Transmitted by Spain

A. PROPOSAL

Paragraphs 2.1.5. to 2.1.5.2., amend to read:

Figure A5.??. Dimensions for the anthropomorphic ballast

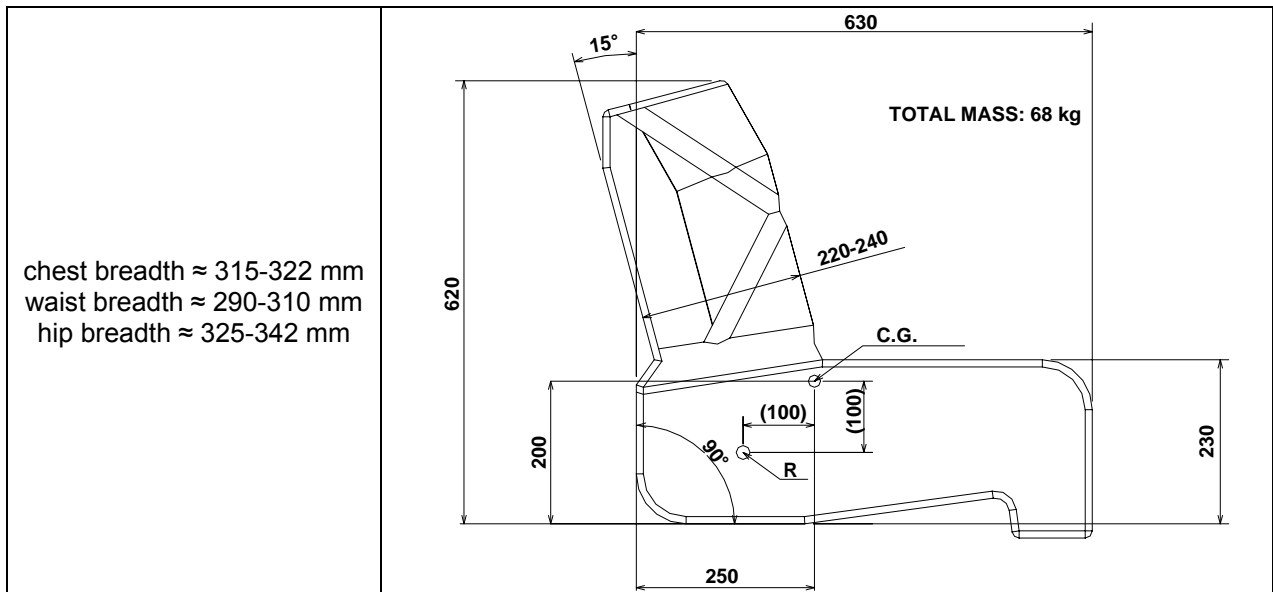
- 2.1.5.1.3 Fixed rigidly and securely so that it does not break away during the test.
- 2.1.5.2 Second method: That mass shall be:
- 2.1.5.2.1. An anthropomorphic ballast with a mass of 68 kg, restrained with a 2 point seat-belt. The ballast must allow guiding and positioning for safety belts.

- 2.1.5.2.2. Placed to have its centre of gravity and dimensions according **Figure A5.??**
- 2.1.5.2.3. This ballast can be replaced by a 50th percentile man dummy.

Fig 1. 50th percentile male dimensions and anthropometric ballast example.

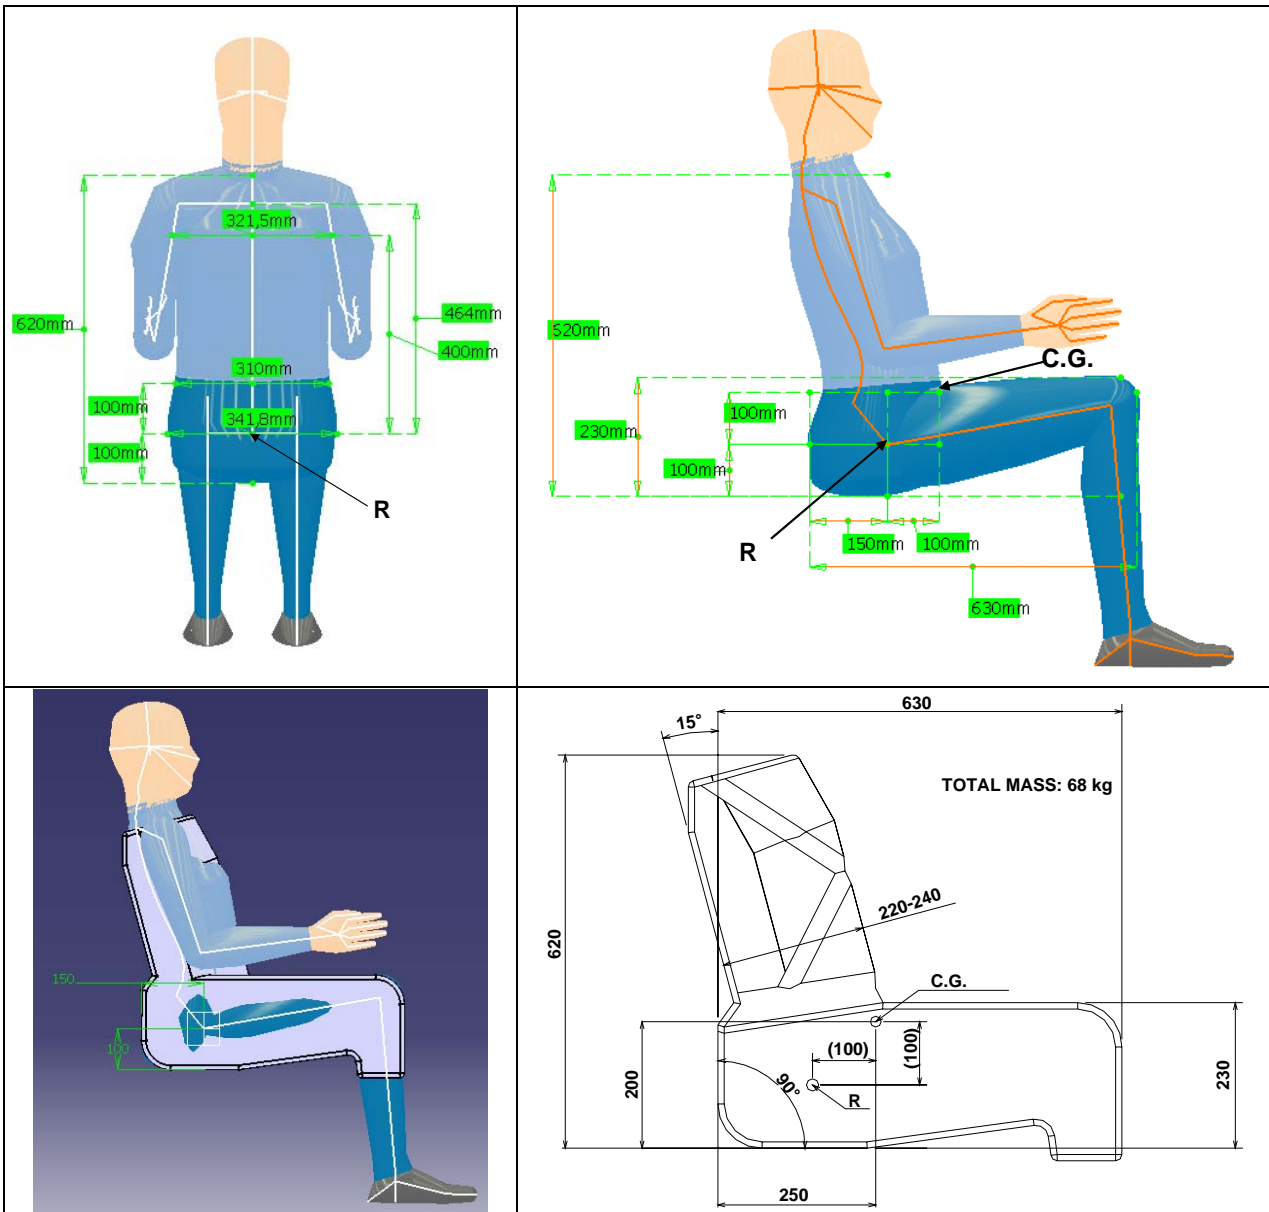
Paragraph 2.1.5.2. Reference for the anthropometric ballast

- The idea is to have economic and easy to use ballasts. Each Laboratory can design its own ones based in the dimensions from a 50th percentile male (Fig 1).
- The ballast must allow guiding and positioning for safety belts.
- Total ballast mass = 68 kg.
- The bench marks related to the centre of gravity (C.G.) and reference point (R) have been obtained from a Hybrid III dummy (seated position, back reclined 15°).
- The width can vary according to next dimensions (obtained from an European and American 50th percentile male):
 - chest breadth \approx 315-322 mm
 - waist breadth \approx 290-310 mm
 - hip breadth \approx 325-342 mm
- The use of dummies (50th percentile man) always represents a worst situation because of the different mass involved. If a test is overcome with dummies instead of rigid or anthropomorphic ballasts, the results must be accepted.
